Engineering Evaluation/Cost Analysis Non-Time Critical Removal Action Tank Farm IR-6

Naval Station Treasure Island
Hunters Point Annex
San Francisco, California
November 13, 1995

Response to Agency Comments of the Draft Engineering Evaluation & Cost Analysis Report for Removal Action at the IR-16 Tank Farm

RESPONSE TO AGENCY COMMENTS ON THE DRAFT ENGINEERING EVALUATION AND COST ANALYSIS REPORT FOR A REMOVAL ACTION AT THE IR-6 TANK FARM

Figure 2-6
PCB Detection Locations
Tank Farm IR-6
Hunters Point Annex

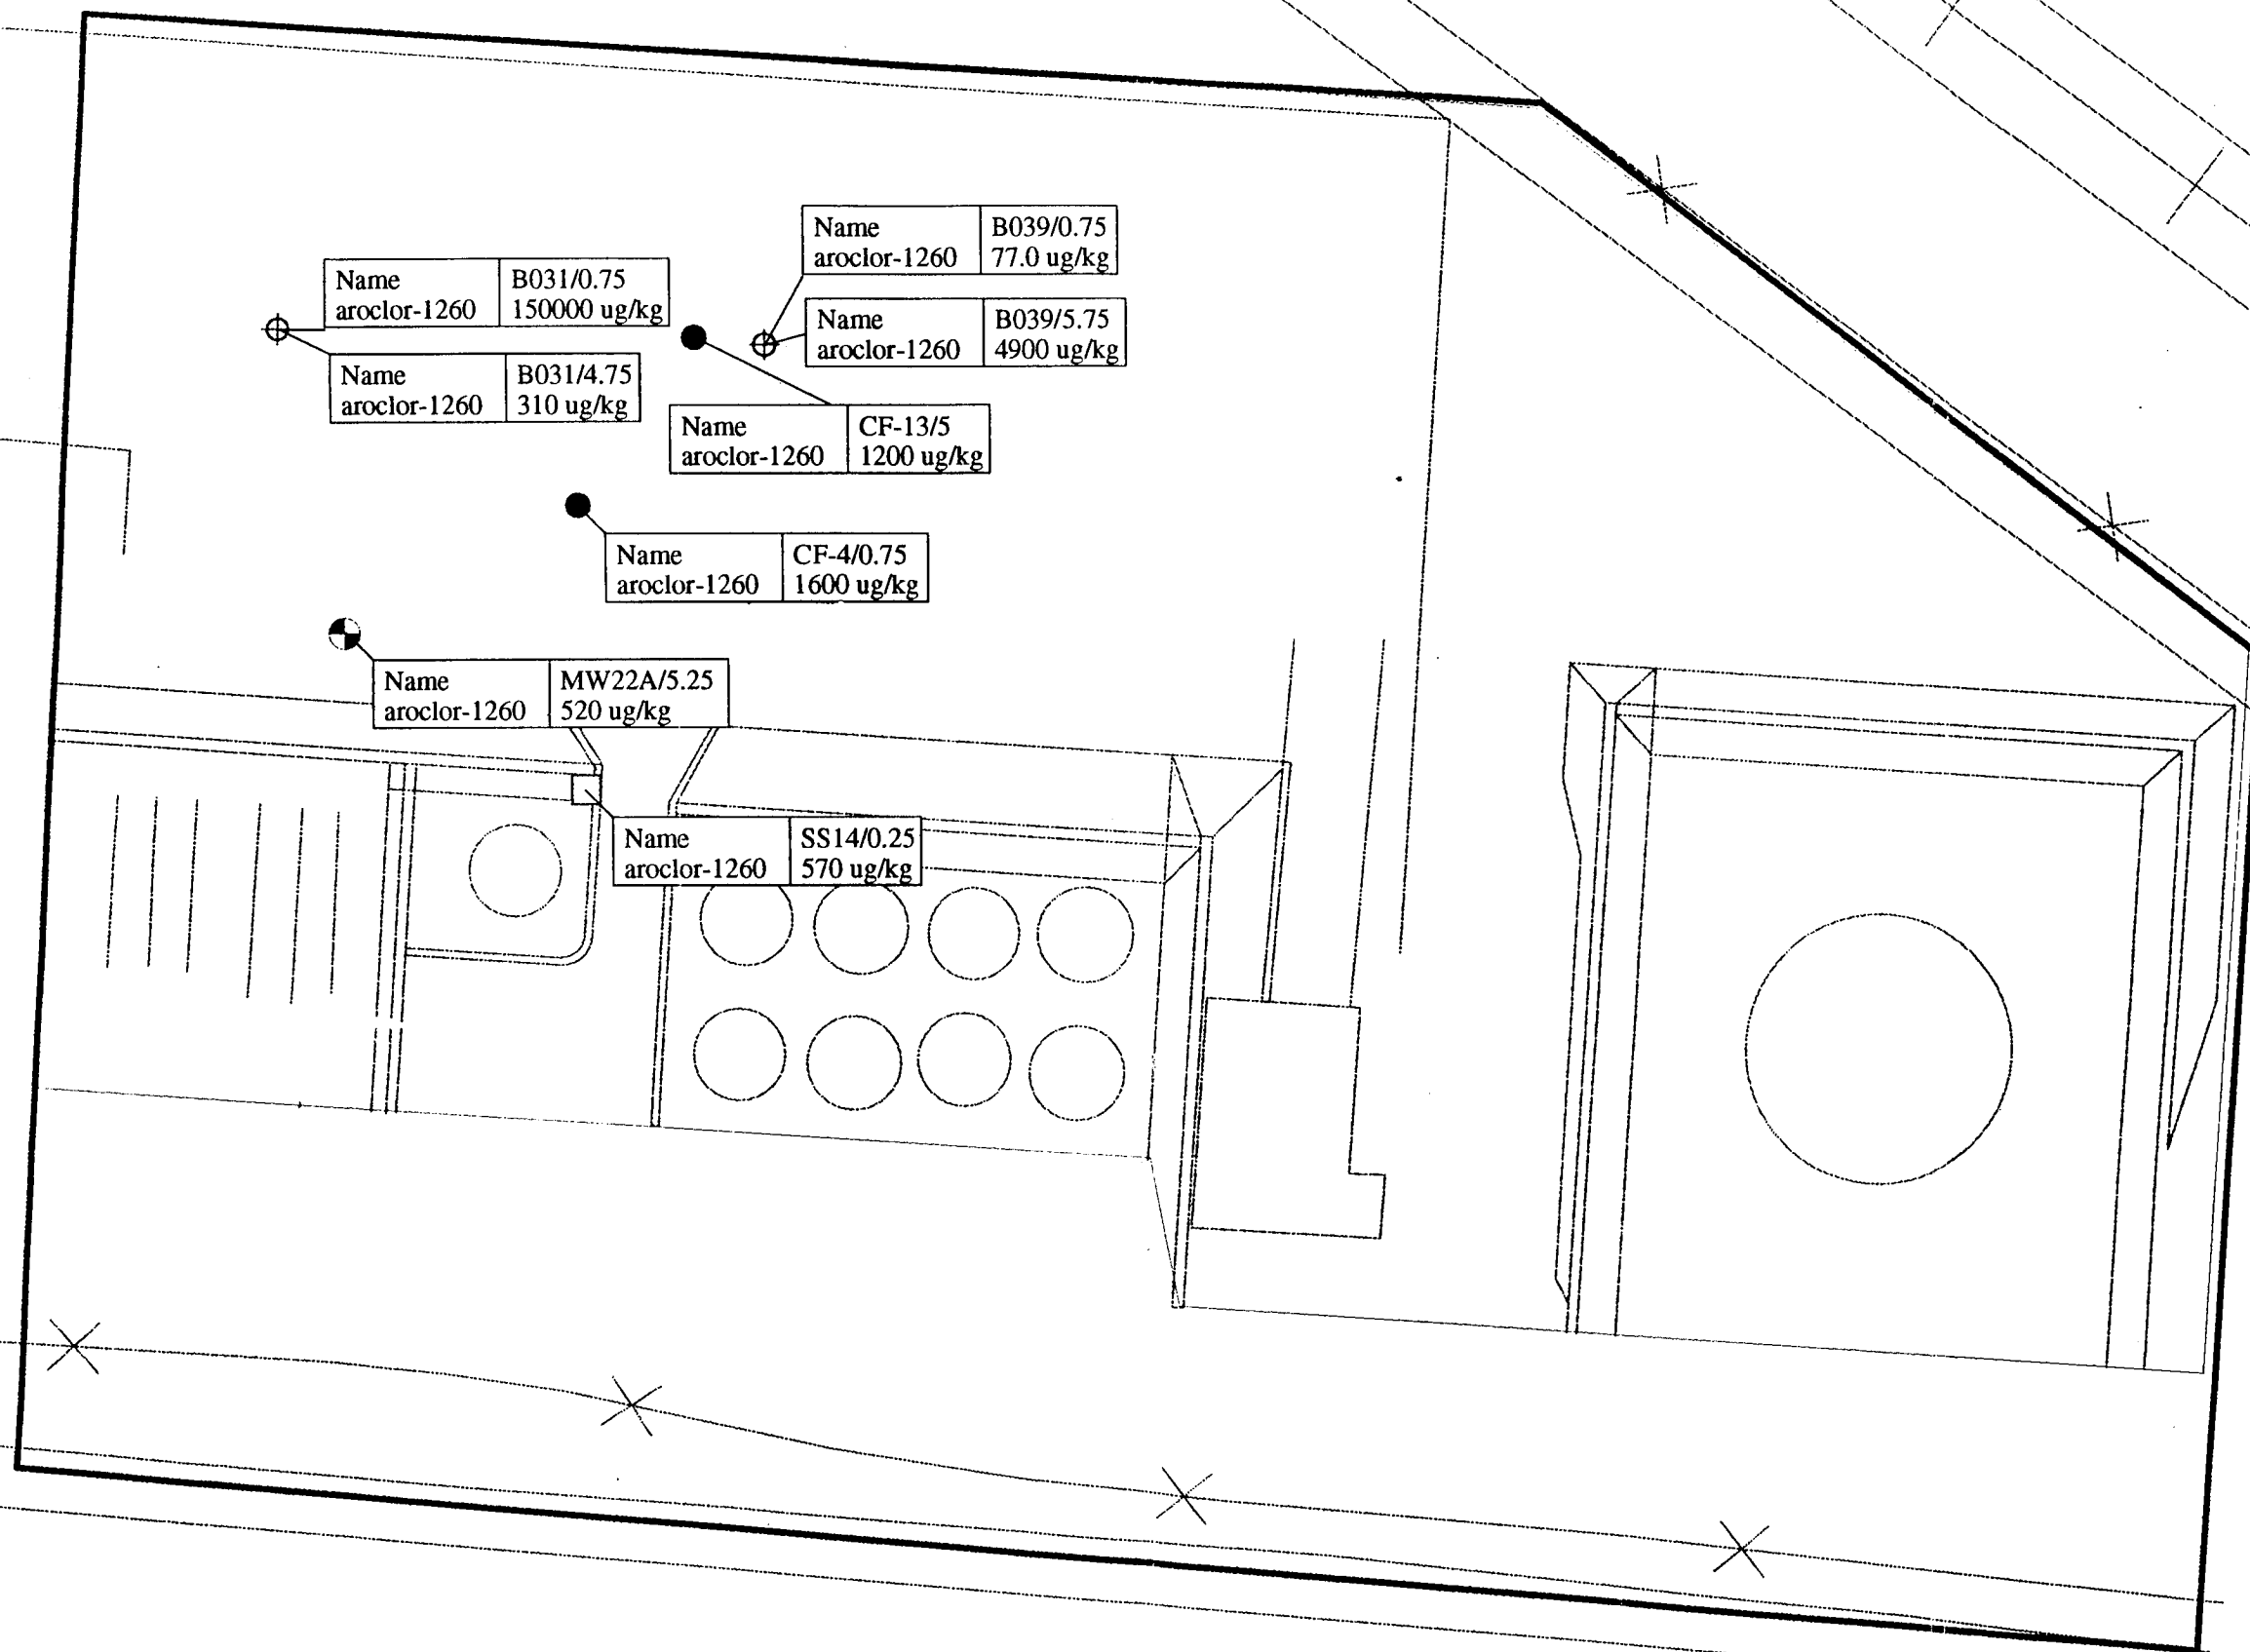
7. *Figure 2-6. Provide a legend for the symbols used on this figure. In particular, depth should be noted.*

A legend is provided for the symbols used on this figure. The depth is noted in the text box attached to each sampling location.

Figure 4-1
Delineation of Removal Action Areas
Tank Farm IR-6
Hunters Point Annex

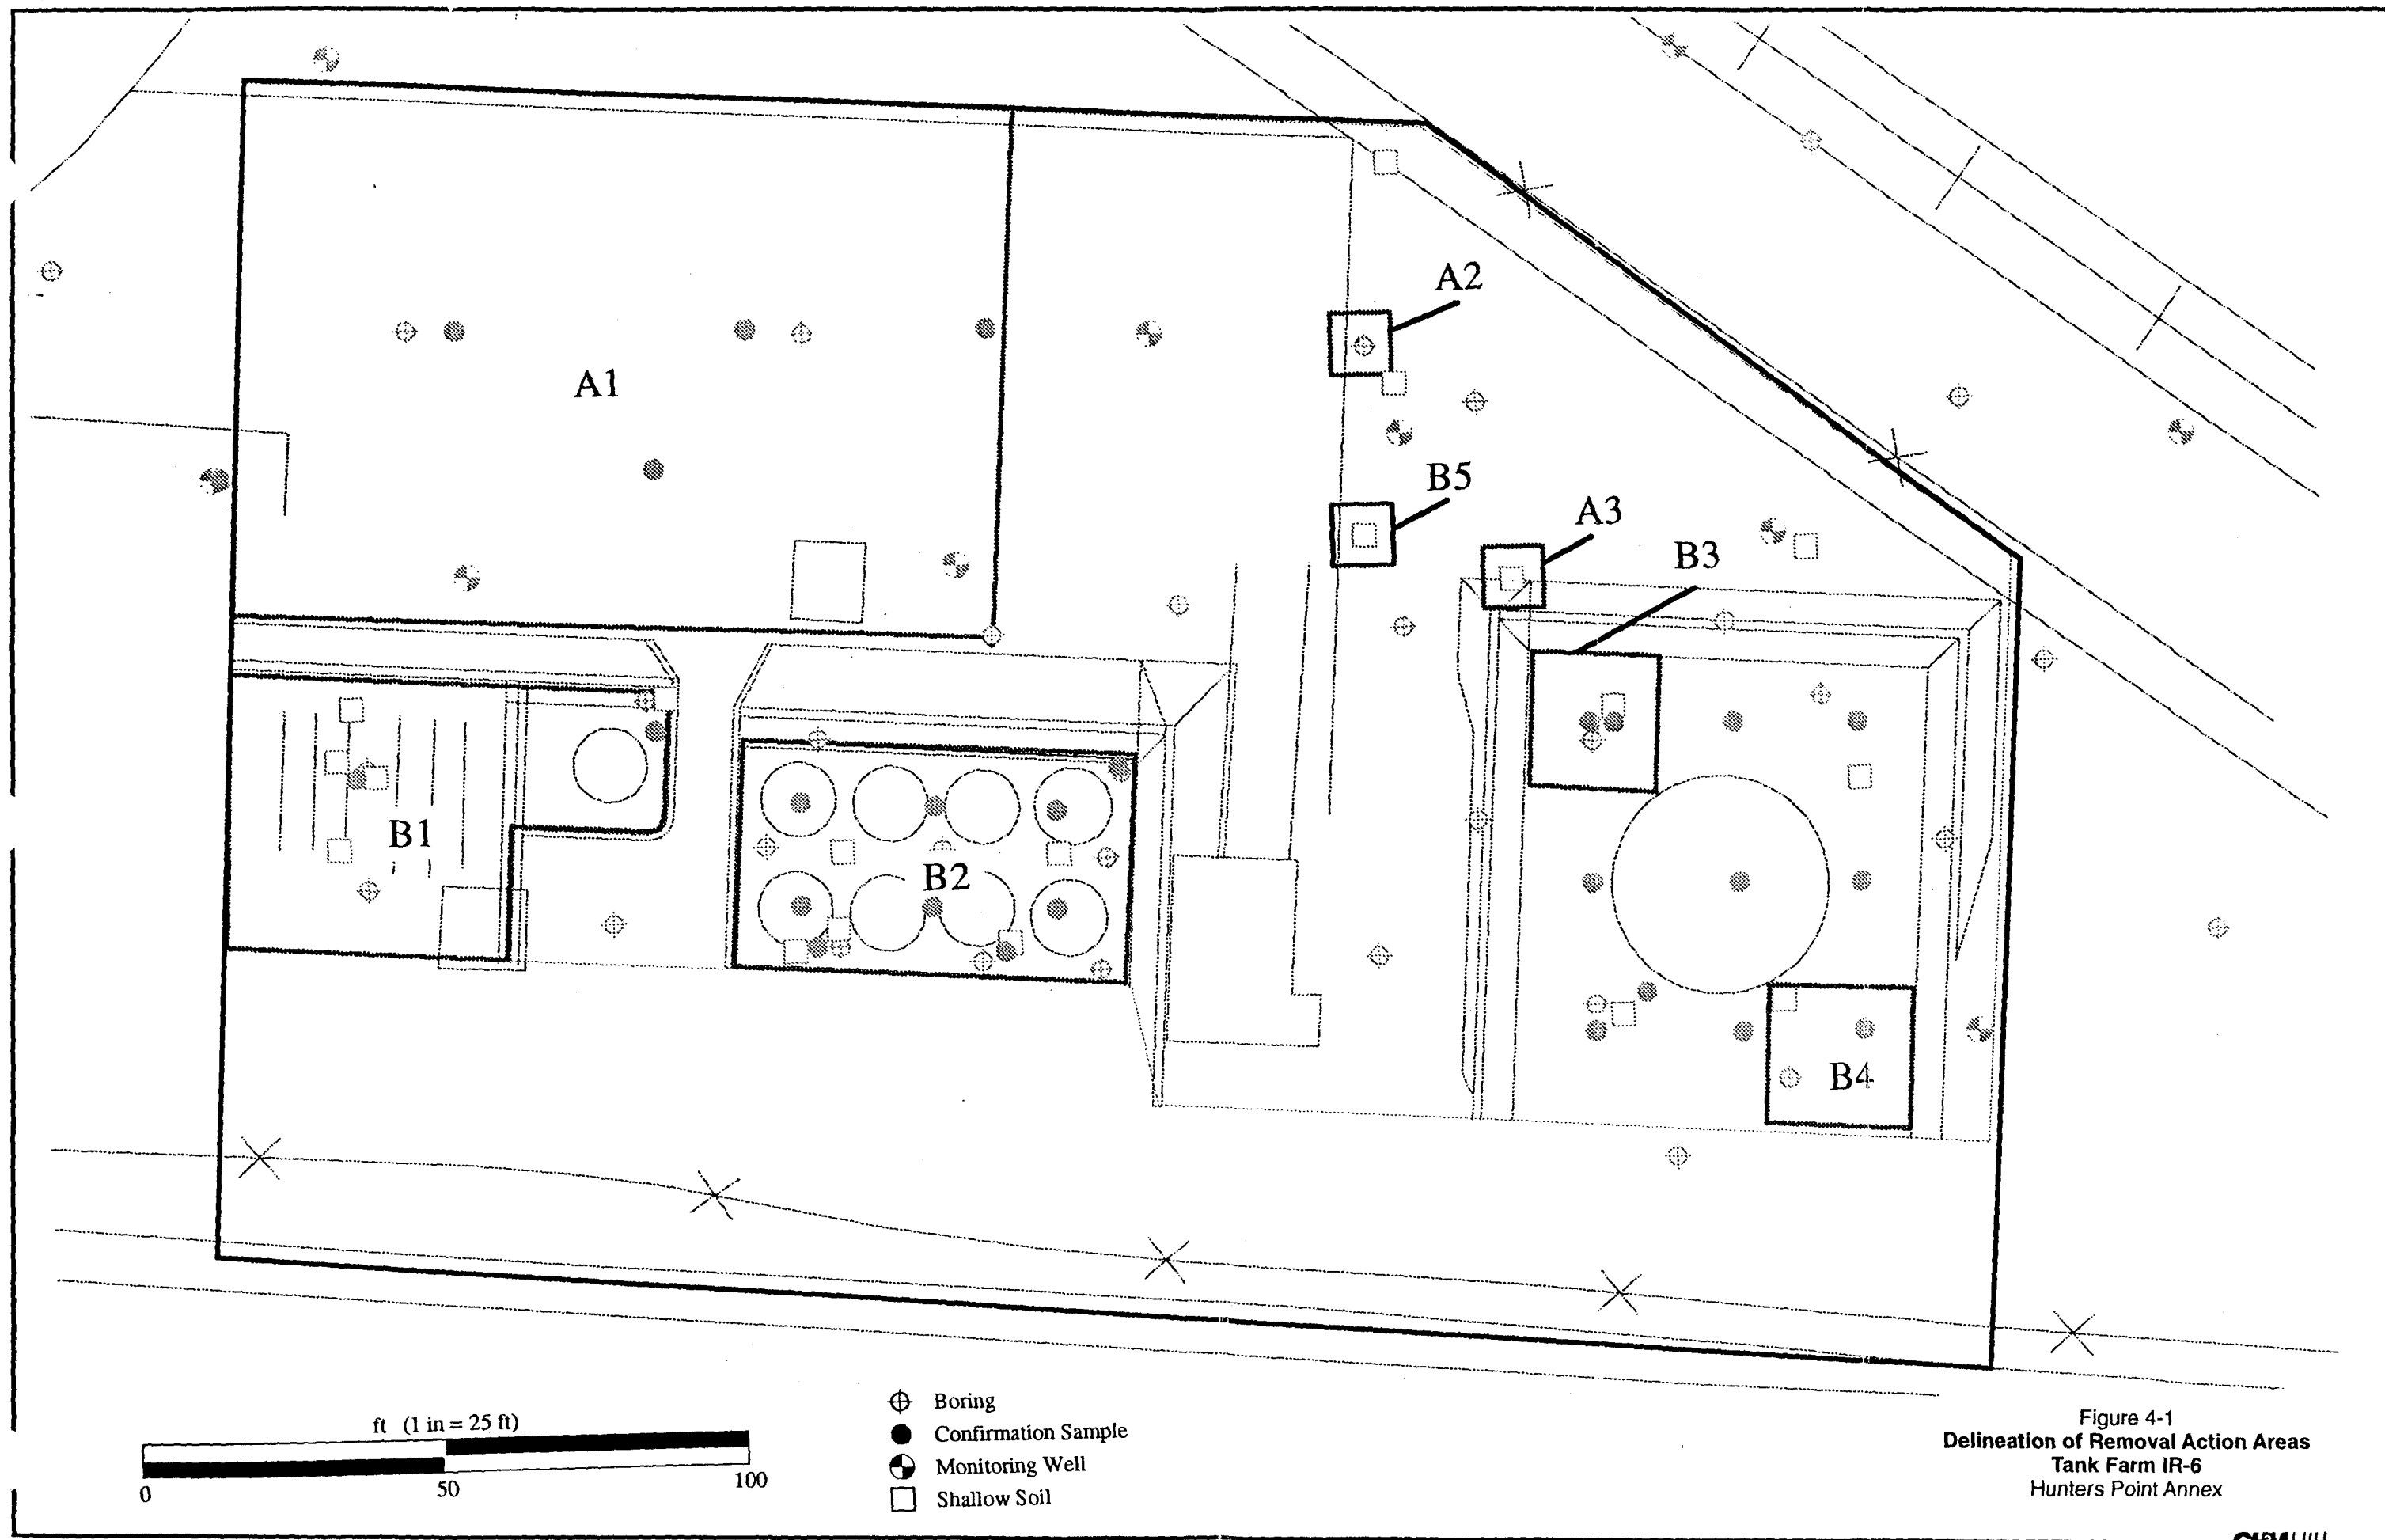
1. *Figure 4-1 presents the proposed areas in the Tank Farm to be excavated. There are several sample points that have metal concentrations above target cleanup levels that are not within the proposed excavations... (examples: SS09, SS19, BO26, BO24, & SS12)*

Samples BO24, BO26, and SS19 contain levels of beryllium above the target cleanup levels. These samples should have been included in the excavation plan. Samples SS09 and SS12 indicated high levels of lead. CH2M HILL collected confirmation samples at these locations and detected much lower levels of lead. Because the Draft Construction Summary Report, Tank Farm Removal Action (HLA, 1993) indicated that soil had been removed in this area during the tank removal, we believe that the confirmation samples better reflect the current soil conditions. Therefore, we did not include these sample locations in the excavation plan. A revised Figure 4-1, which indicates the current excavation plan, is attached.
